MANDATORY**SEL-24-10****TITLE**

ELECTRICAL POWER - MASTER CONTROL UNIT S/N INSPECTION AND REPLACEMENT OF WIRE HARNESS

March 12, 2019

Figure 1. MCU Wire Harness (Sheet 1)

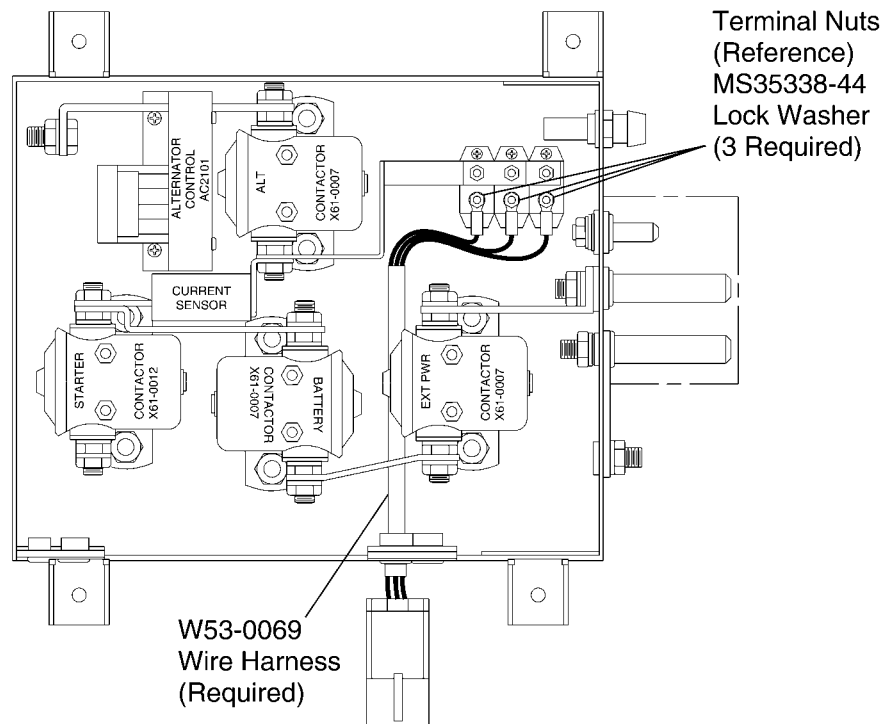
Some S3100-594 Master Control Units (MCU) have been found with improper terminal crimps on the electrical connector for the W53-0069 Wire Harness. A terminal crimp that is not correct can have a loose connection which can cause electrical arcing that can lead to an electrical fire and/or complete loss of electrical power.

4. Remove the front cover (and cooling shield for T206H airplanes) from the MCU.
5. (Refer to Figure 1.) Replace the W53-0069 Wire Harness in the MCU as follows:

- A. Disconnect the electrical connector for the W53-0069 Wire Harness.
 - B. Remove the three terminal nuts and MS35338-44 Lock Washers; keep the nuts and discard the lock washers.

- C. Remove the W53-0069 Wire Harness keeping attention to the routing of the wires inside the J-Box.
 - (1) Make the removed W53-0069 Wire Harness unusable by cutting the connectors off and discarding.

- D. Install the new W53-0069 Wire Harness with the wires routing the same as the removed wire harness.
 - E. Install the three terminals, MS35338-44 Lock Washers, and kept nuts; torque the nuts to 25 Inch-Pounds.

- F. Connect the electrical connector for the W53-0069 Wire Harness.
